SERVICE BULLETIN

UTILITY TRAILER MANUFACTURING CO.

SB-08-200

Subject: BENDIX SR-5 VALVE Recall – INTERIM NOTIFICATION

Bendix® SR-5™ Valve

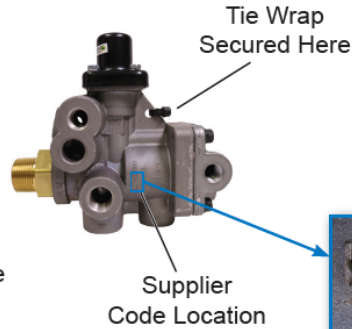
To verify that the Bendix® SR-5™ valve has been repaired per the recall campaign, look for the presence of a black or green tie wrap secured to the valve body. **No further action is required.**

Green Tie Wrap
(supplied in recall repair kit)

Valve Identification

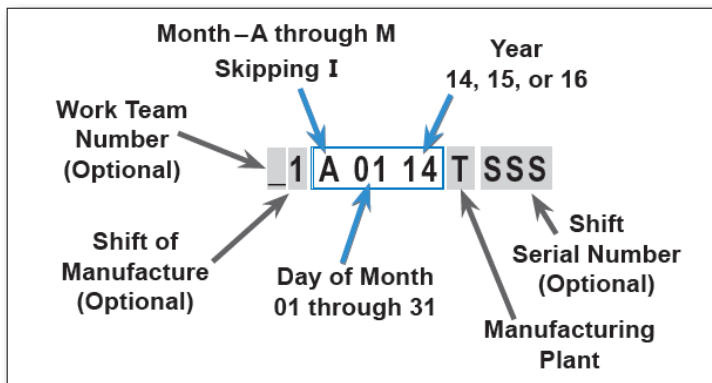
The Bendix SR-5 valves covered by this campaign can be identified by the supplier code and the date of manufacture located on the valve body. Verification of both is required to determine if the valve is a part of the campaign. Valves covered by this campaign must meet the following criteria:

1. The supplier code—"IKD"—cast in the body and located as shown in the illustration above; and
2. The date of manufacture between January 1, 2014 and March 4, 2016, inclusive. To verify the date code see *Interpreting the Date Code* below.

Sectional view of check valve assembly in seated position

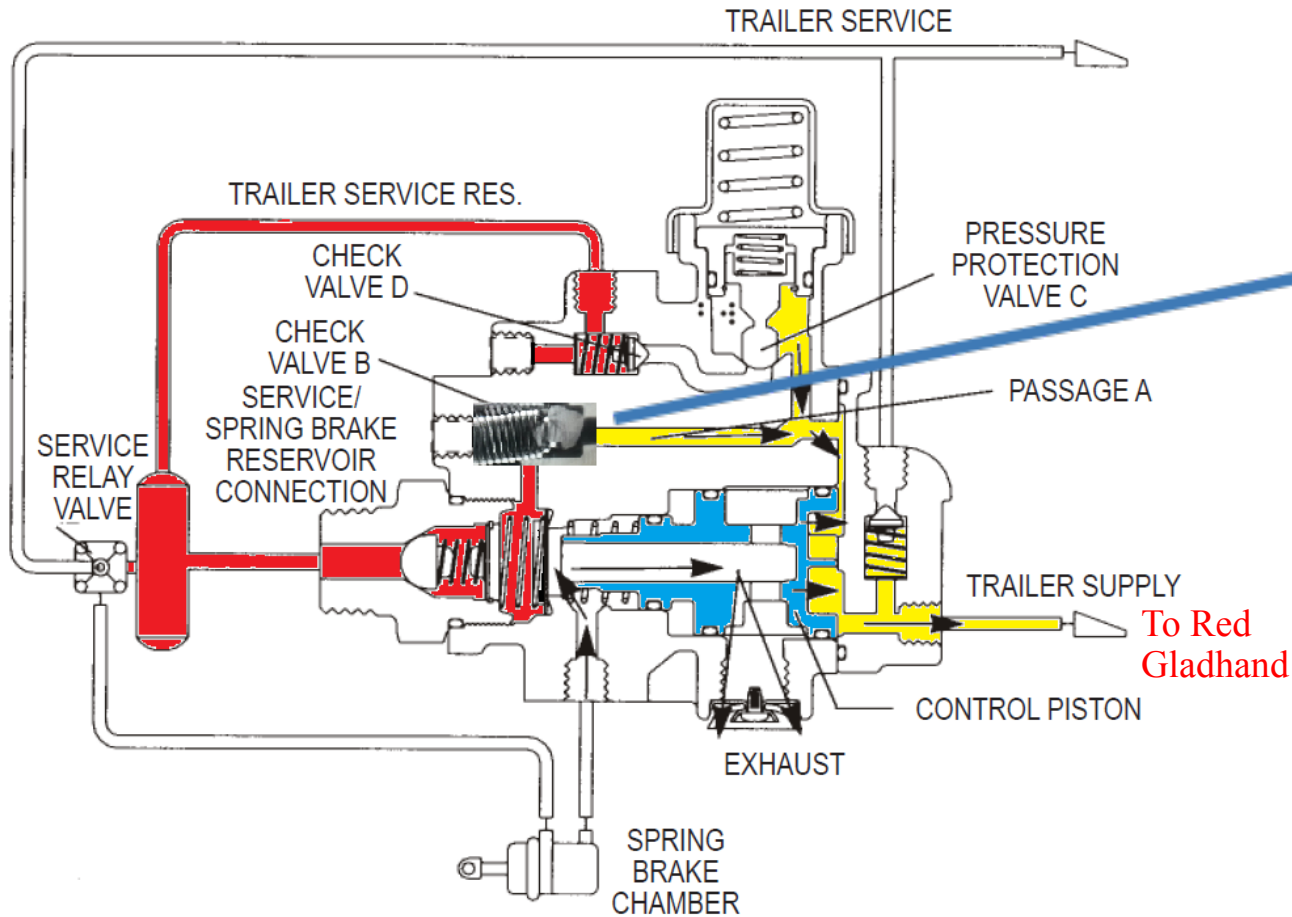
Missing Radius on Aluminum valve Body

When combined with certain field conditions – causes misalignment of internal Check Valve

Caught on Sharp Edge

Missing Radius on Valve Body

Check Valve seat
(Radius Present / Radius Not Present)

If Valve becomes Misaligned, Leakage can be Large enough to cause 'Slow to Park'

Production Remedy - Re-introduce Radius on Valve Body (Began on Mar 4, 2016)

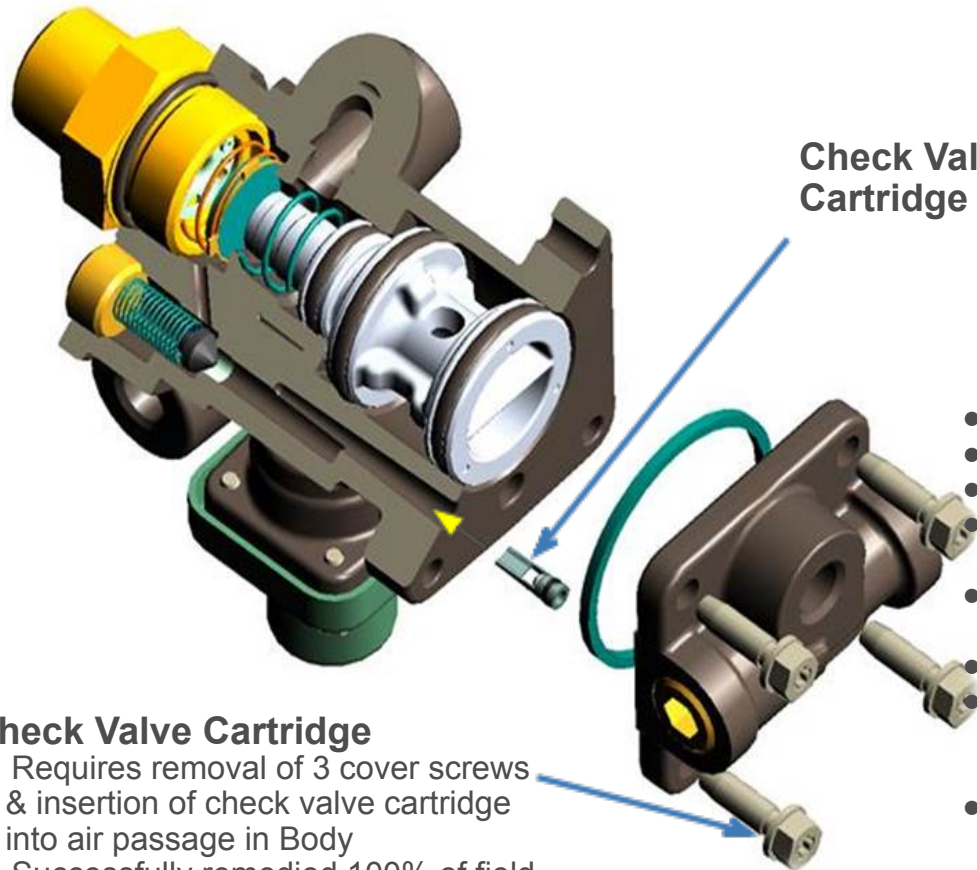
Missing Radius on Aluminum valve Body

When combined with certain field conditions – causes misalignment of internal Check Valve

If Leakage is present (& large enough), the leaking air provides enough back pressure on the main control piston (**BLUE**) to prevent normal movement.

If the main piston does not move, immediate exhaust (<3 seconds) cannot happen.

This is how the leakage from the check valve is causing the 'slow to park' condition.

Once leakage fully exhausts tank pressure, the backpressure drops, the main piston moves & the trailer parks.

Missing Radius (combined with other conditions) can cause leakage – preventing immediate parking

Check Valve Cartridge

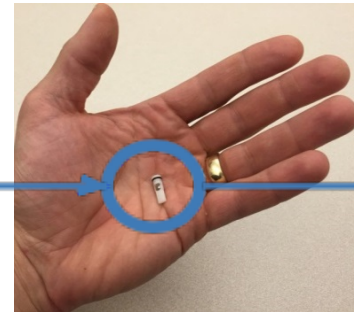
Field Remedy – Field Rework Procedure to insert a Redundant Check valve cartridge in air passageway. Procedure will not require removal & replacement of SR-5.

Check Valve Cartridge

- Requires removal of 3 cover screws & insertion of check valve cartridge into air passageway in Body
- Successfully remedied 100% of field returns w/ issue.
